Lower Thames Crossing

**Thurrock Council's Comments on Applicant's Submissions at Deadline 4 (D4)
and Deadline 5 (D5)**

31 October 2023

Thurrock Council

Figure 11.1: Comparison of Benefit Cost Ratios (BCR) for HS2 and LTC

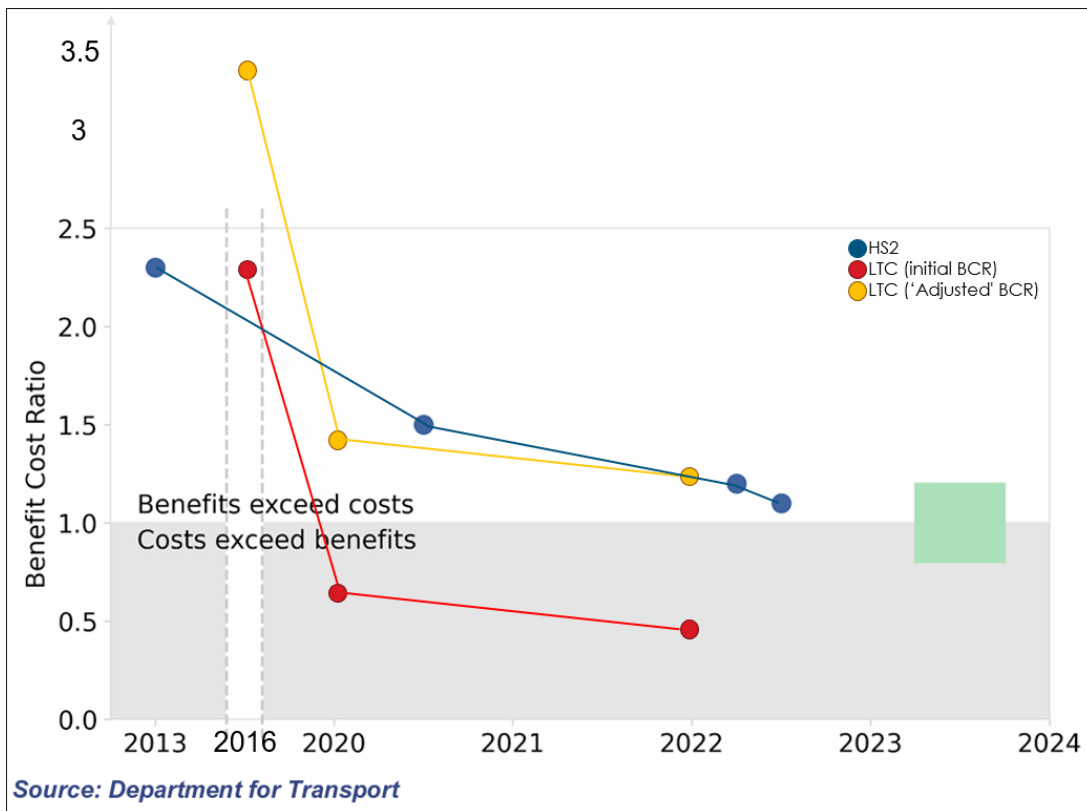
11.2.13 This analysis shows that, like HS2, the case for LTC has massively weakened. The BCR has fallen consistently as the scheme has developed with the BCR for well-established Level 1 benefits is only 0.48:1 and with all benefits is only 1.22:1. This is much lower than the BCR of 3.44:1 identified in the initial assessments of the LTC. As described by the further analysis by Professor Phil Goodwin presented in Sections 10.3.23 – 10.3.37 above, in fact the estimate of the BCR for LTC needs to be reduced further to c1.0:1 to reflect changes in recent DfT guidance on modelling.

Figure 11.2: Plate 4.13 Relative Delay Plot (2045 DS 17:00-18:00) – extract from (REP1-189)

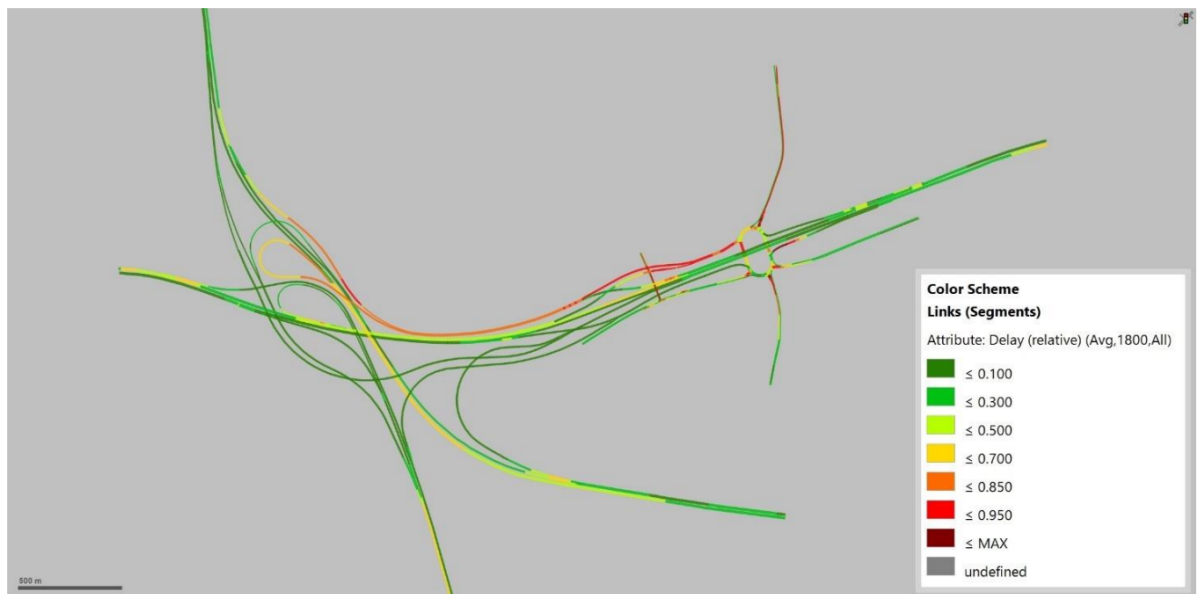
- 11.3.61 The Council continues to raise concerns with the level of queuing and delay forecast in the PM peak period at the LTC off-slip where it is required to weave over only 90m with traffic exiting the A13 on the A13 eastbound off-slip. This is shown in **Figure 11.2** below, which is an extract of Plate 4.13 of [\(REP1-189\)](#) for the 2045 Do Something PM peak hour. The VISSIM modelling currently shows that the mean maximum queue on the A13 eastbound off-slip is over 2.2km in 2045 Do Something PM peak hour. The applicant forecasts this level of queuing on a 'typical day' and therefore queuing could be worse than this on some days.

- 11.3.62 The weave length is currently designed to be 90m but modelled as 200m in VISSIM. Even with a weave length of 200m, it is not sufficient to accommodate the queuing traffic. The Council raises safety concerns with traffic weaving over such a short distance. The short weave length would increase the risk of collisions, which would result in queuing back onto the mainline.

- 11.3.63 The Council has also raised a number of other safety concerns with the design of the junction in the LIR ([\(REP1-281\)](#)), which have not been addressed.

11.3.64 The applicant has recently updated the VISSIM modelling (V3.6) for Orsett Cock, which was issued on 20 October 2023. The Council is in the process of reviewing the updated modelling and will provide a detailed review at Deadline 6A or 7, which will also consider the safety implications of queueing and delay forecast at the junction.

Plate B.1 Change in flow as a result of 1 TBM, AM peak, phase 2

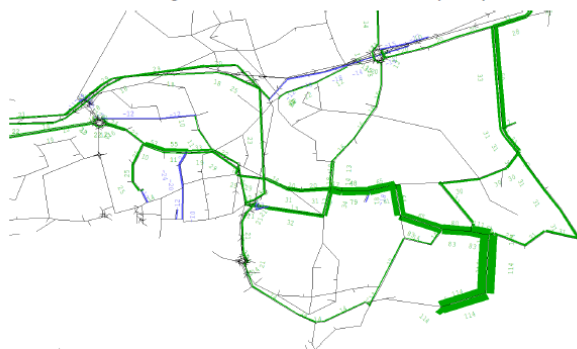
- 13.2.10 Due to this lack of clarity, it is not possible to accurately assess the construction period effects.

- 13.2.11 Furthermore, in response to Section C3.1.6 and Table C4.1, the applicant has pointed out that the FCTP figures in Table 5.3 of the FCTP are two way and this is noted. While it is noted that FCTP Table 5.3 shows two-way movements, these figures are generally and consistently higher than those assumed in the AM construction traffic model (CTM). The figures are, significantly higher still than those assumed in the IP and PM models. The Council does not
